CORRECTIONS

Flexural-Torsional Buckling and Its Implications for Steel Compression Member Design

Paper by CYNTHIA J. ZAHN and NESTOR R. IWANKIW
(4th Quarter 1989)

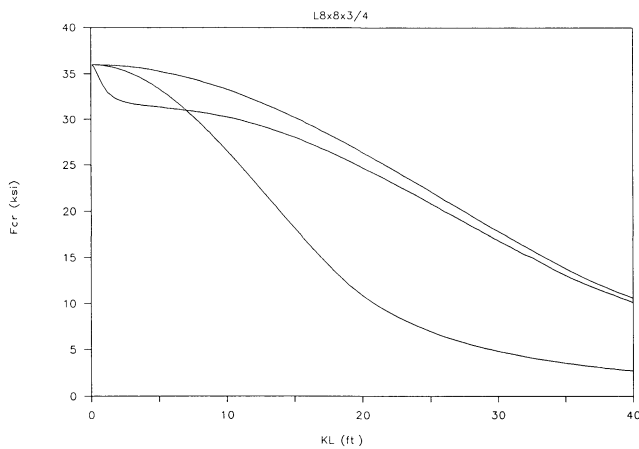
- p. 149: Caption for Fig. 11a should read, "Critical stress for $L8 \times 8 \times 1\frac{1}{8}$ (axis of symmetry is major axis)"
- p. 149: Caption for Fig. 11b should read, "Critical stress for $L8 \times 8 \times \frac{3}{4}$ (axis of symmetry is major axis)"
- p. 149: Replace Fig. 11b with the following figure:
